ADDENDUM NO. 1**BID CALL NO. T2024-036****REPLACEMENT OF COMPLETE POWER DISTRIBUTION, ASPHALT PAVEMENT, LIGHT
STANDARD AND ELEVATOR UPGRADE AT PROFESSOR'S LAKE RECREATION
CENTRE**

PROJECT NAME: Power distribution, Asphalt and light standard replacement

ADDENDUM NO.: #1

The following amendments are hereby made as part of the Contract Documents. The following revisions and/or additions shall be made to contract documents and the cost shall be included in the Tender Price.

SITE PLAN - NEW

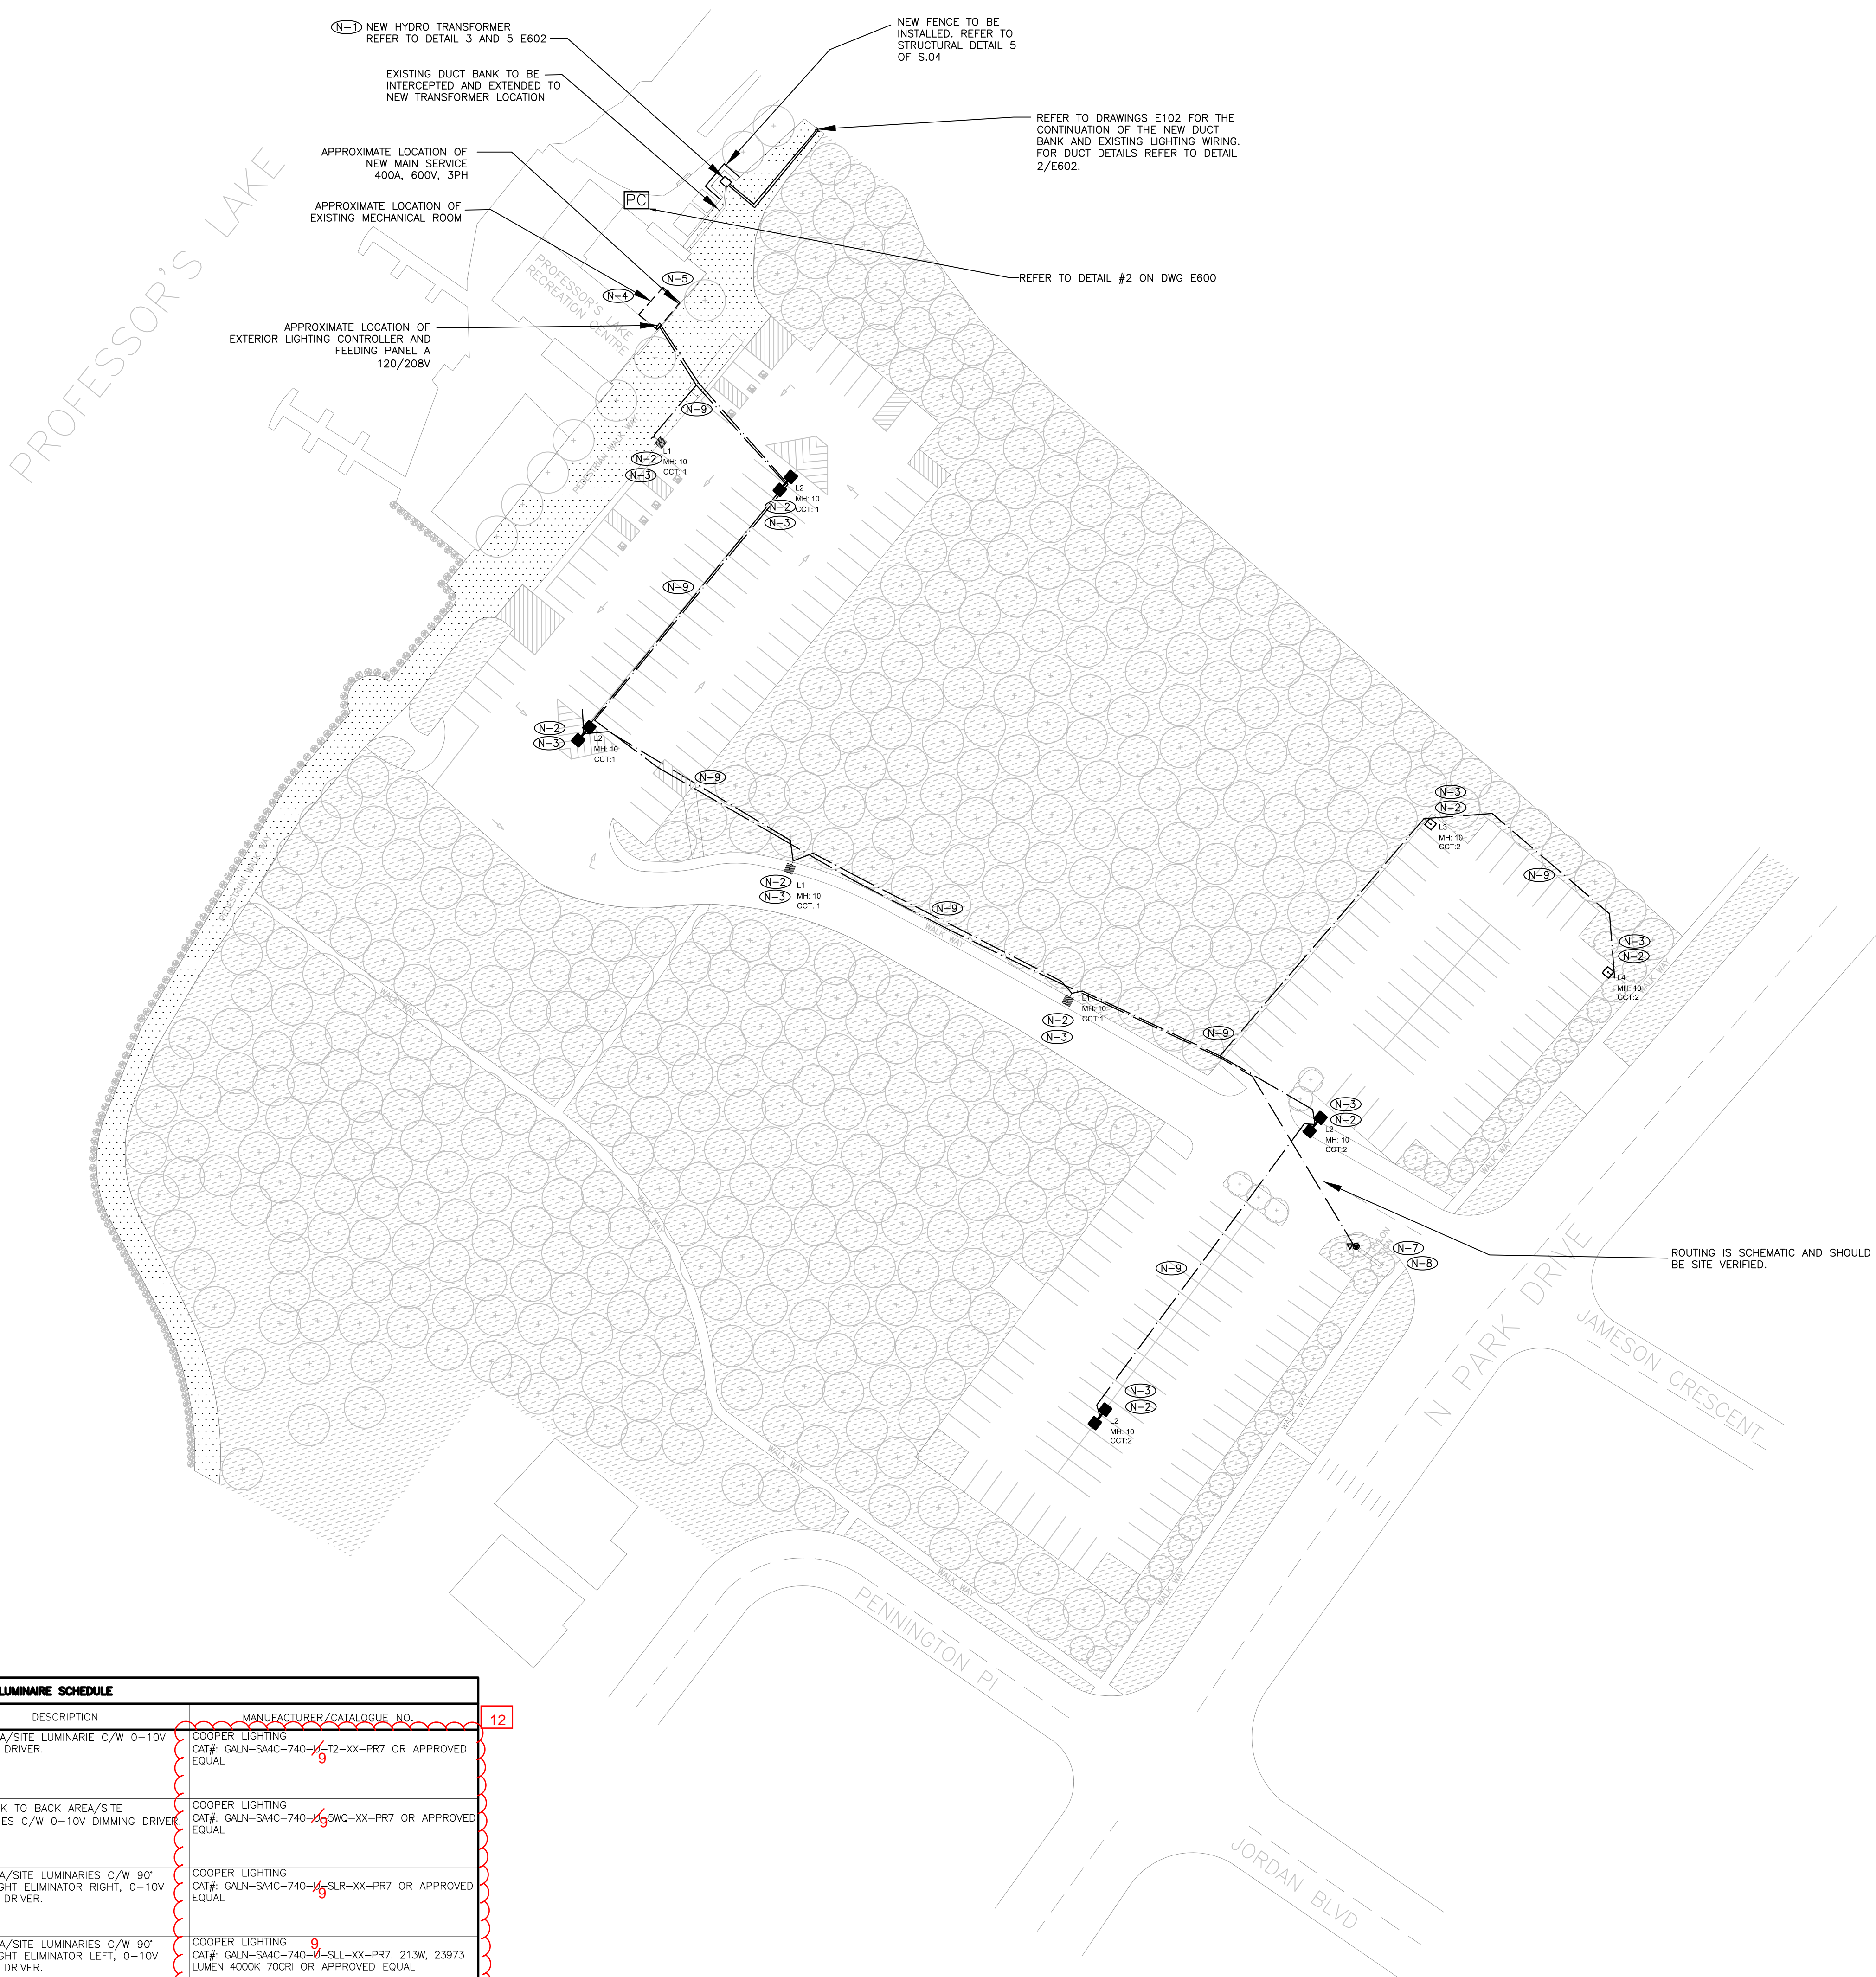
1.1 Refer to E101 - SITE PLAN-NEW (included herein)

1.1.1 The luminaires rated voltage is changed from 120V to 347V. The cat# has been revised as noted.

1
E300 GROUND FLOOR – POWER AND SYSTEMS

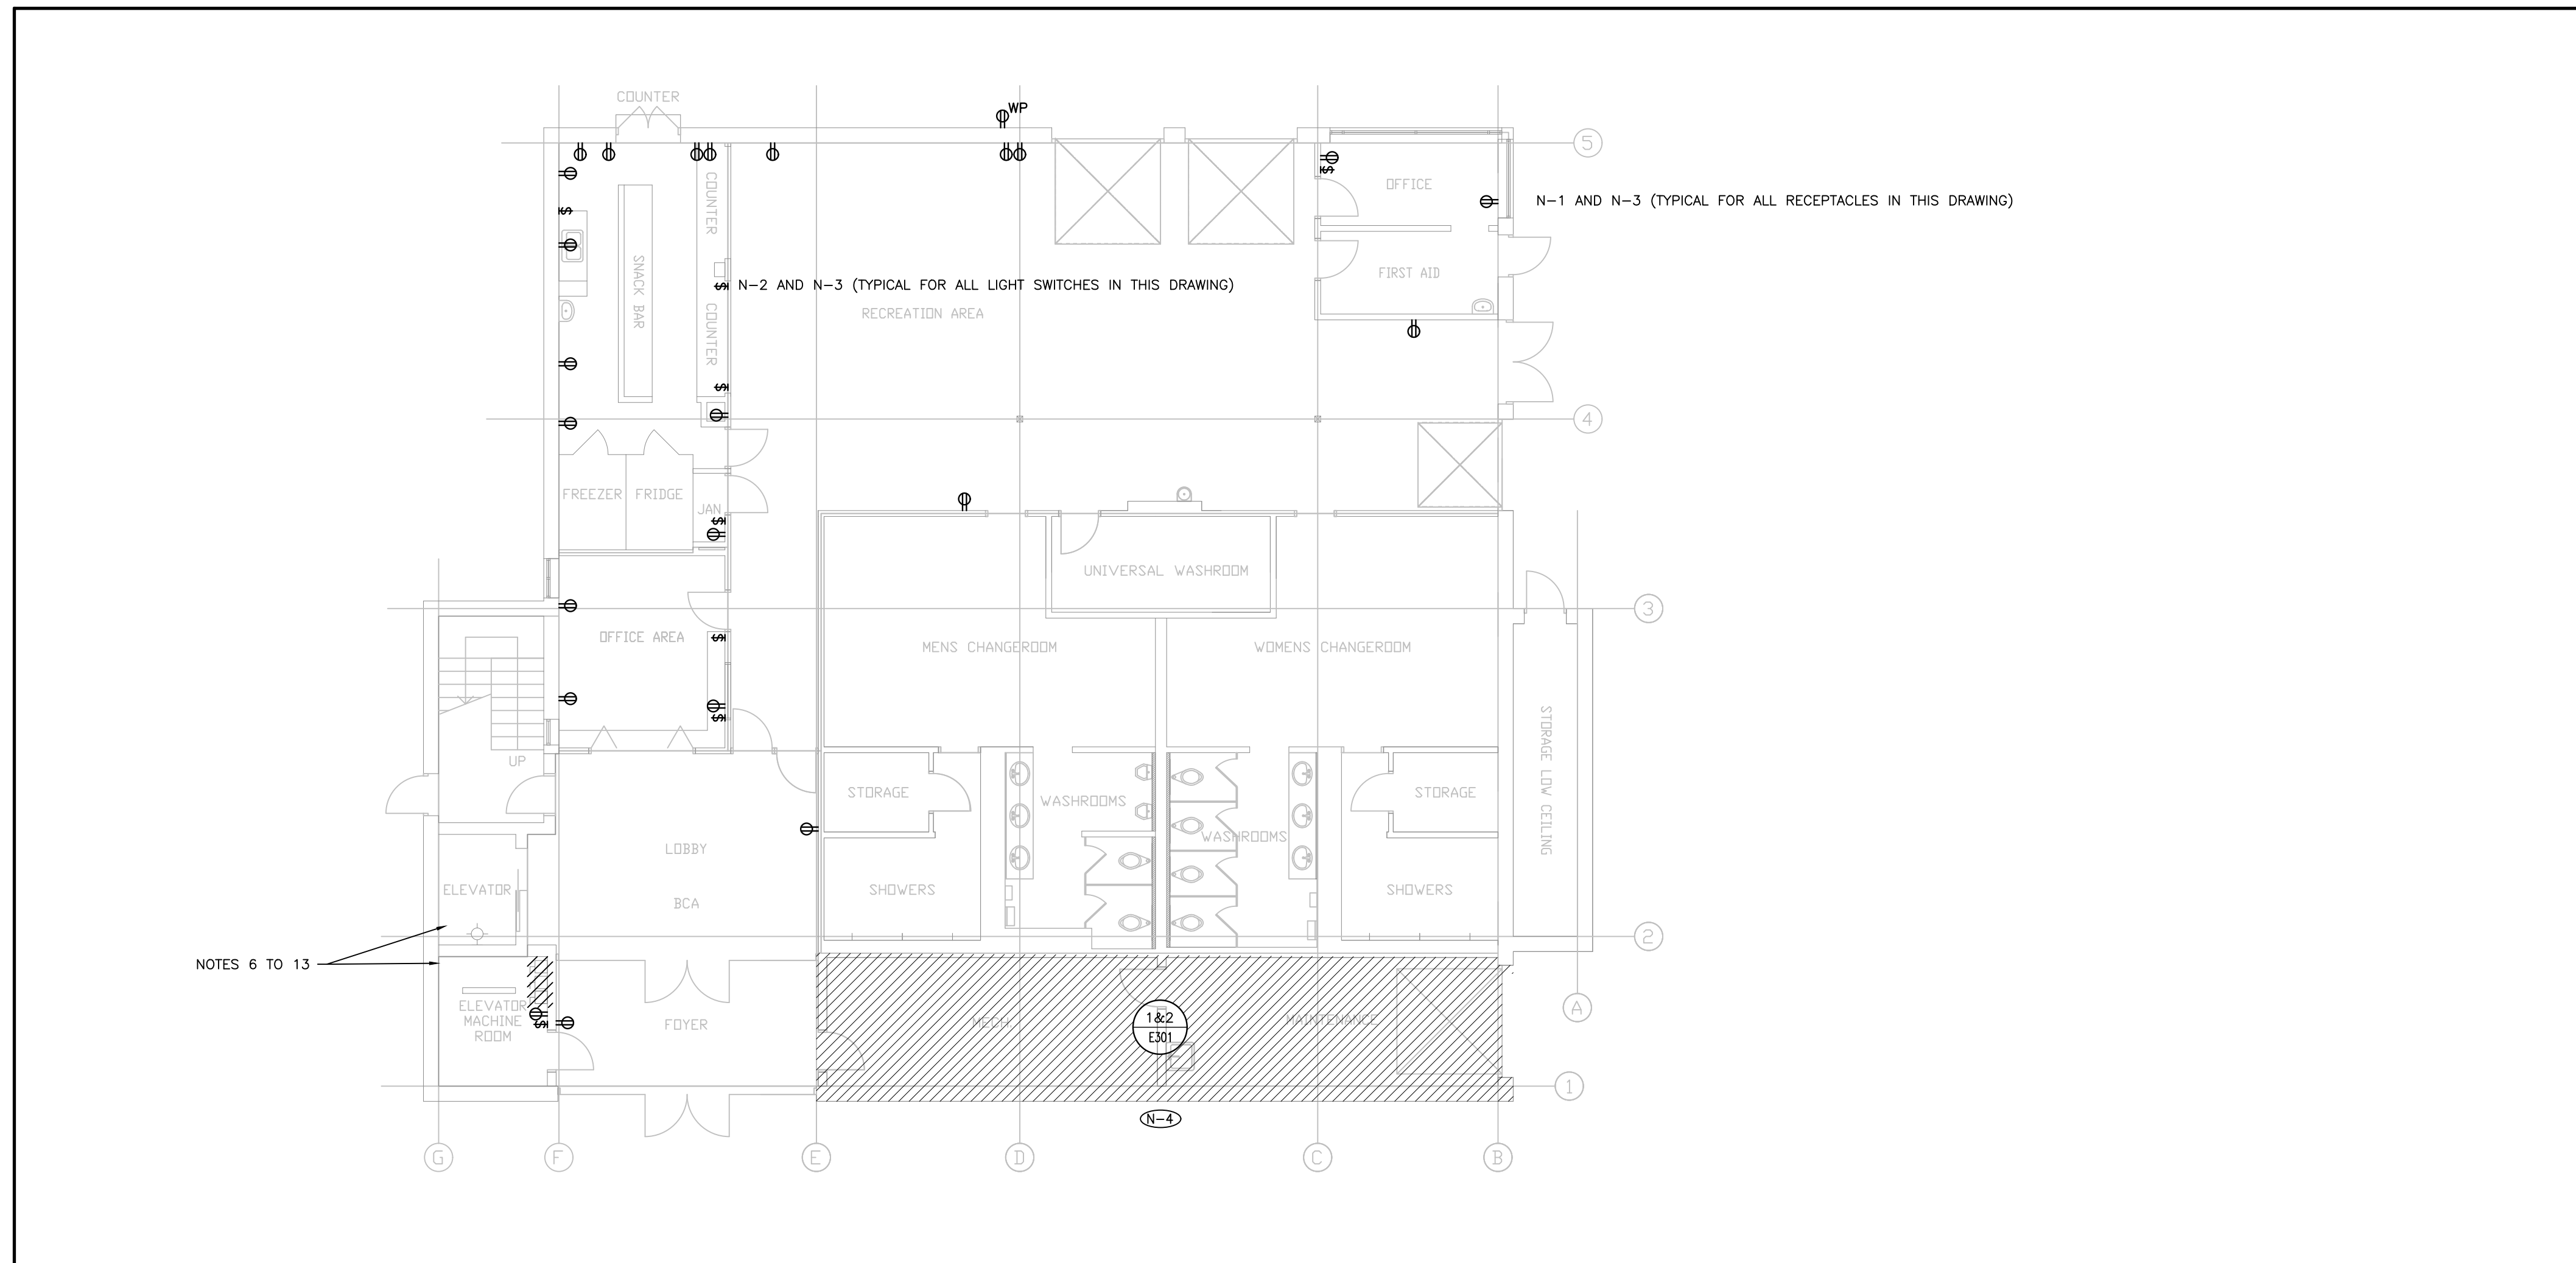
1.3 Refer to detail 1, E300

1.3.1 Supply emergency lighting remote head complete with battery pack sized for at least 1.5-hour lighting during shutdown, install in the elevator room and feed through closest emergency feeder.

GROUND FLOOR MECHANICAL ROOM POWER AND SYSTEMS

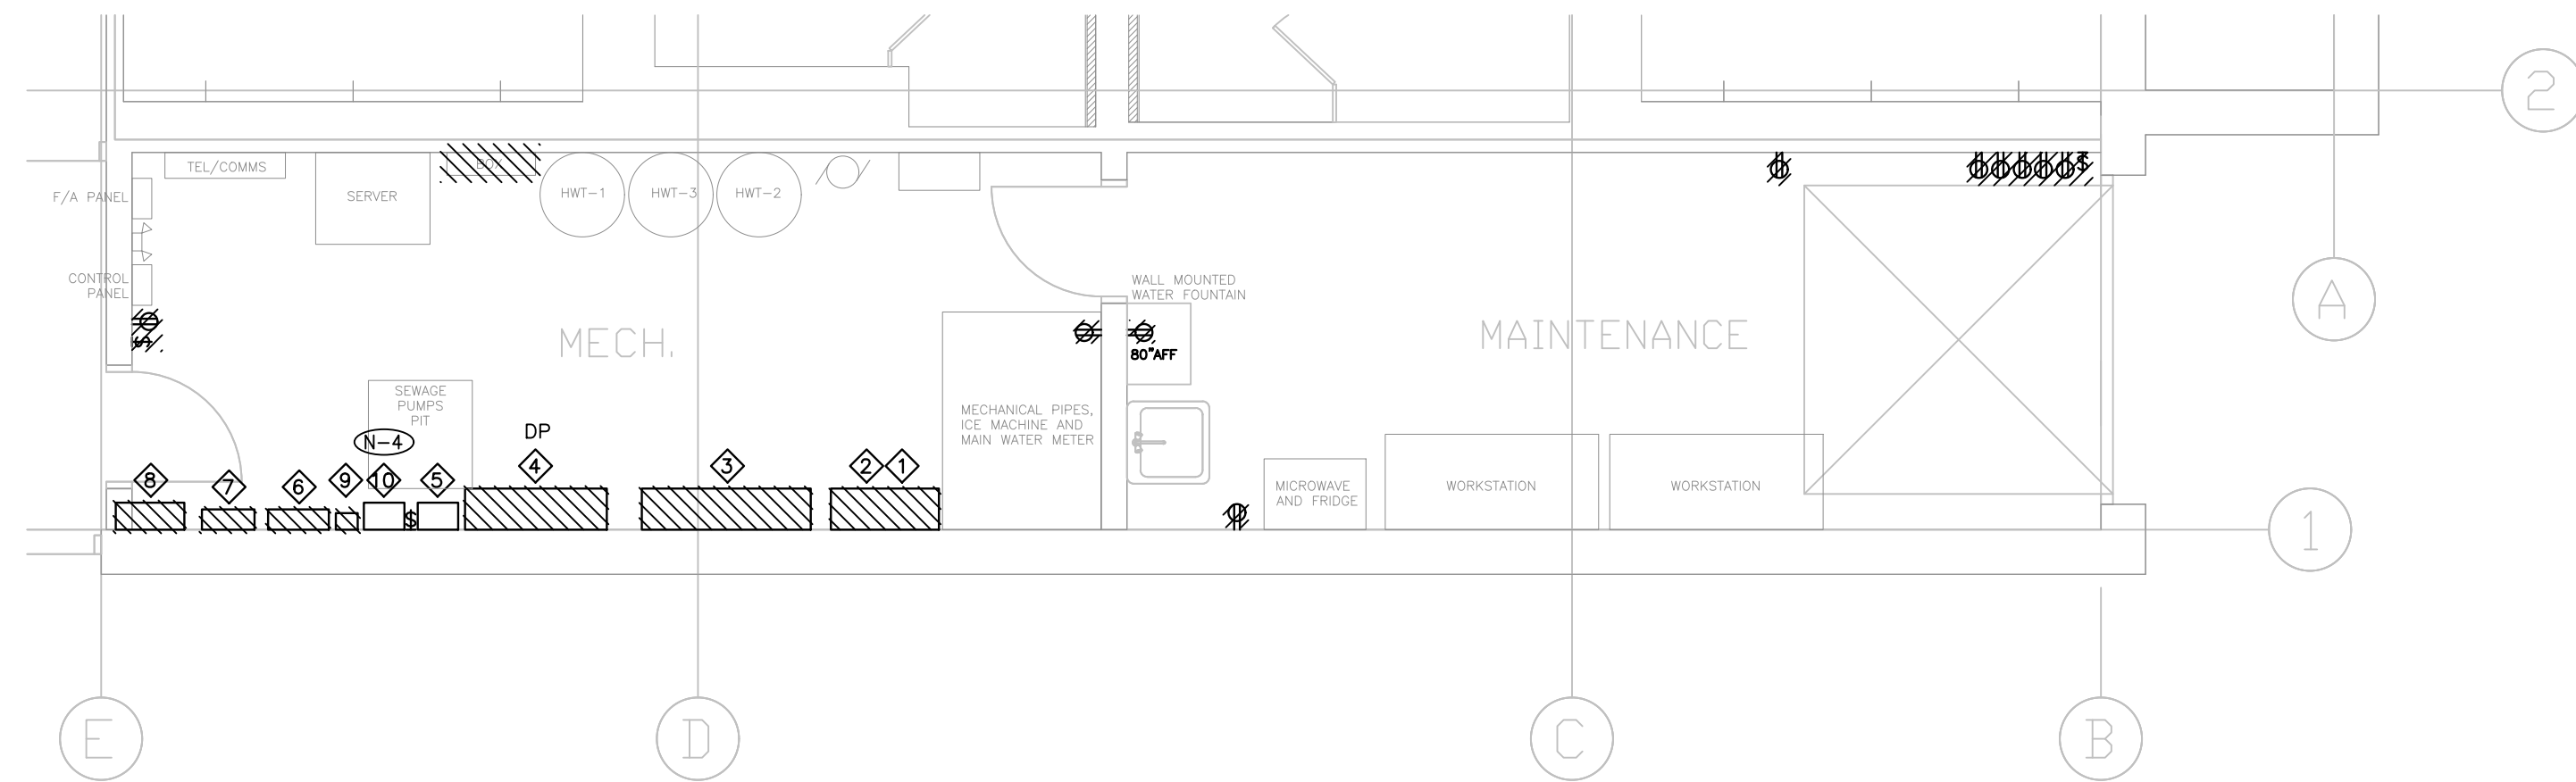
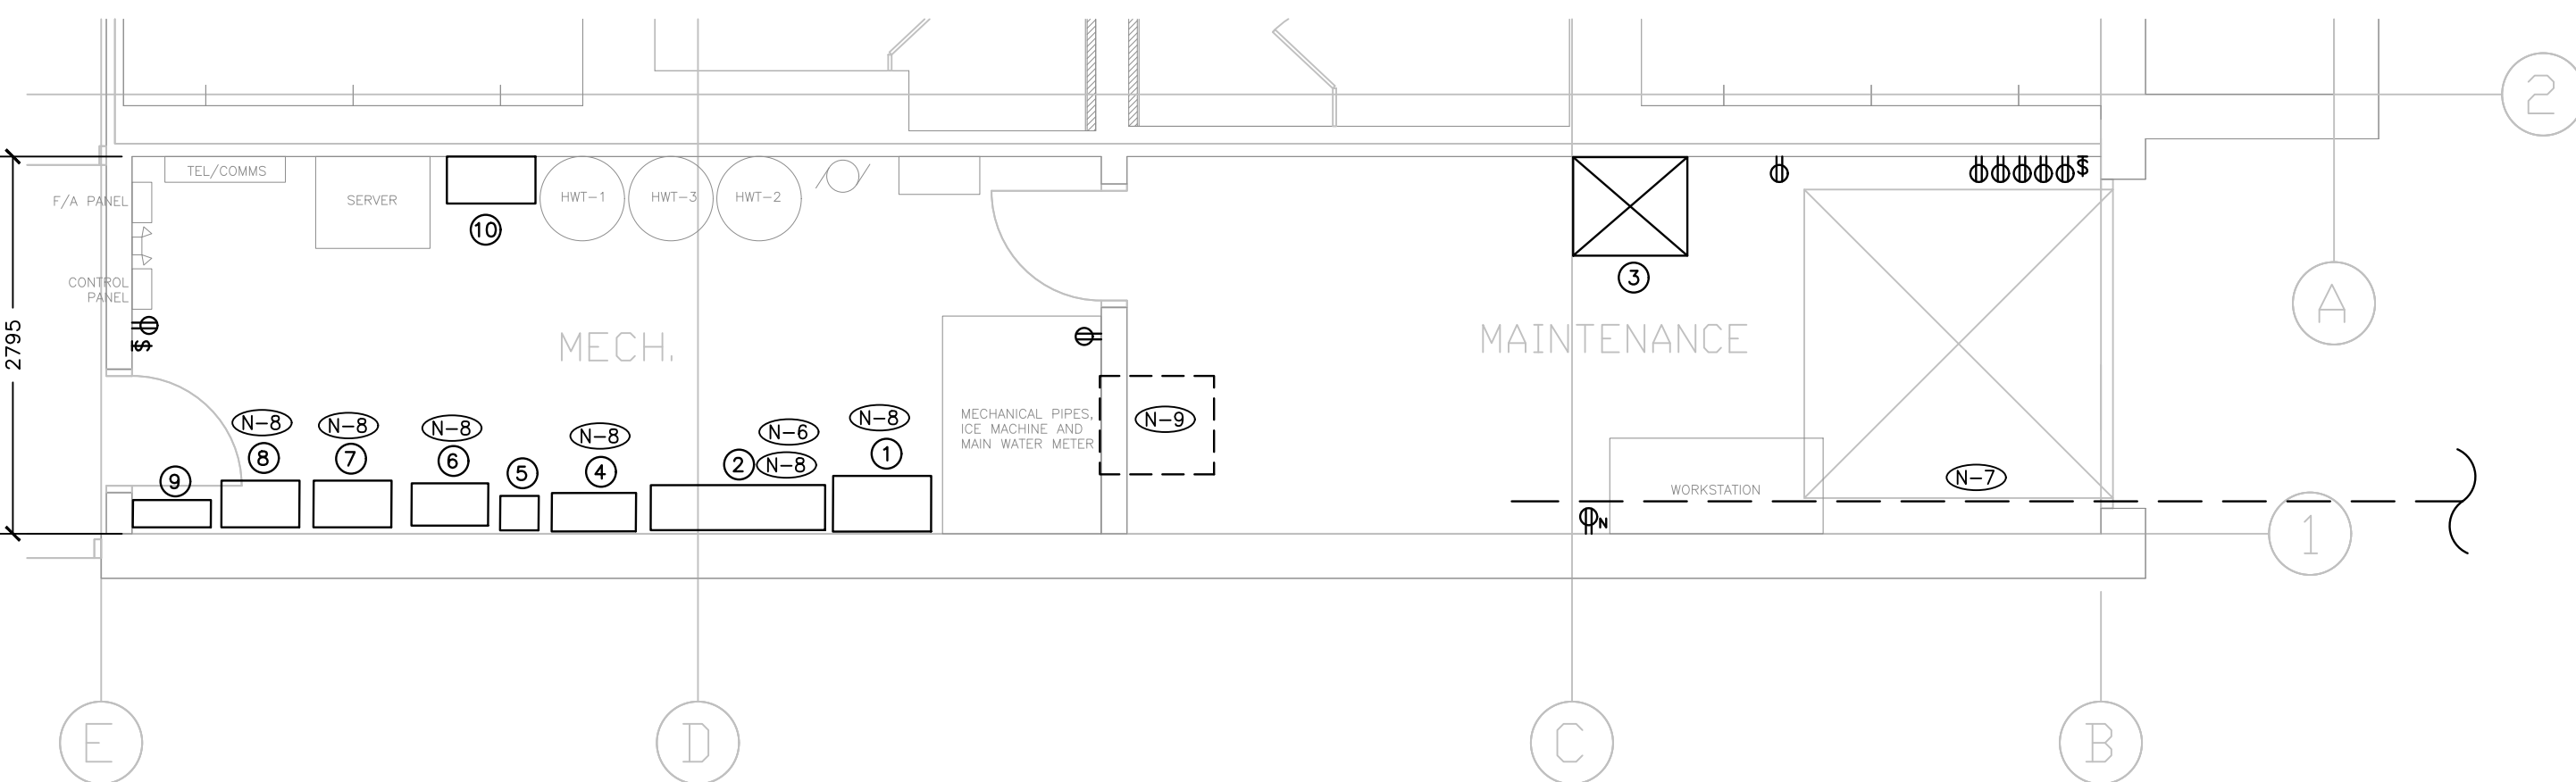
1.2 Refer to E301-Ground floor mechanical room power and systems (included herein)

1.2.1 The Meter model is changed to PM5563.
